**CALIFORNIA INSTITUTE OF TECHNOLOGY
MASSACHUSETTS INSTITUTE OF TECHNOLOGY**
Laser Interferometer Gravitational Wave Observatory (LIGO) Project

| Refer to: | LIGO-T040058-00 |

IOT1 LAYOUT AND MODE CLEANER REFLECTION PORT

Figure 1: Schematic view of current H1 IOT1 layout.

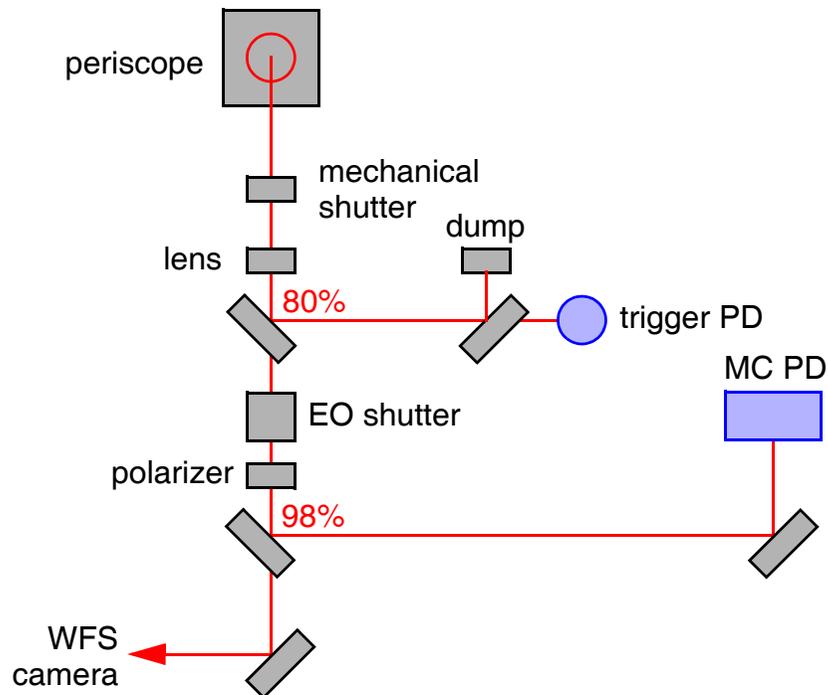
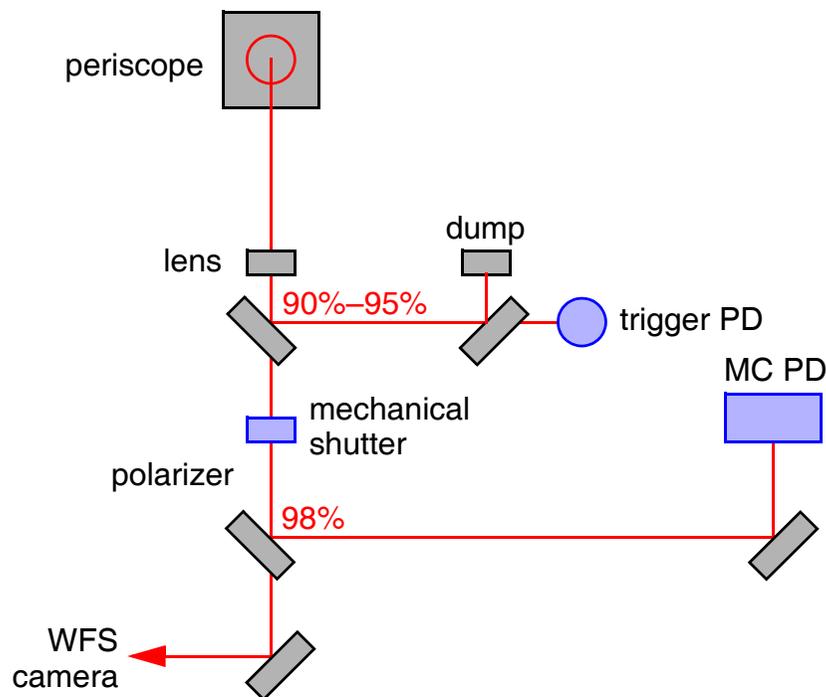
This is a proposal to remove the EO shutter at the mode cleaner reflection port (IOT1 and IOT7). This should allow for a simpler beam path with reduced acoustic couplings and for reliable operations with higher laser power.

Figure 1 presents the current layout of IOT1. For H1 about 80% of the light is dumped ahead of the EO shutter. The EO shutter is operated with a high and low transmission state selected by the amount of light detected on the trigger photodetector. During lock acquisition the EO shutter lets

about 10% of the light through. With 800 mW available on the PSL table this yields about 16mW of light on the mode cleaner length sensor. When the mode cleaner is locked the reflected light decreases by a about a factor of 30 and the EO shutter switches into its high transmission state letting 100% of the light through. With the same 800mW on the PSL table this gives about 5 mW of light on the MC length sensor. During the switch to common mode the light into the mode cleaner is slowly increased while reducing the EO shutter transmission accordingly. This keeps the optical gain of the mode cleaner length and alignment servos constant during the transition. One problem when going to higher power is that the trigger level has to be set low enough to allow for the switching during lock acquisition. A reasonable trigger level corresponds to about 100mW–200mW of light at the periscope. However, at full 8W input power this level is exceeded even when in lock.

As it turns out the EO shutter isn't really required and the mode cleaner could equally well be operated without it—as long as a mechanical shutter is installed to prevent high light levels to burn out the MC length sensor. Figure 2 presents the proposed new layout of IOT1. To allow for higher input power 90%–95% of the light is dumped at the head of the beam path. The EO shutter has been eliminated and the mechanical shutter has been installed in its place. The mechanical shutter is controlled from the trigger photodetector to close down when the power at the MC length sensor exceeds ~30mW. To lock the mode cleaner the power at the PSL table is reduced to approximately 50mW–100mW. This guarantees that the light power on the MC length sensor does not exceed 10mW. When the mode cleaner locks, the power at the PSL table is set back to its

normal value—800mW in the case of H1. This will yield about 2.5mW of light on the MC length sensor. During the transition into common mode the power could be increased to as high as 8W. This will give 25mW of light with the 90% dump, or 12.5mW with the 95% dump. To account for the increased optical gain the electronics gain of the MC length and alignment systems have to be reduced correspondingly. If the mode cleaner loses lock at nominal input power of 0.8W or higher, the mechanical shutter will be closed automatically. The shutter will open again, if the power on the PSL table is reduced below ~300 mW.
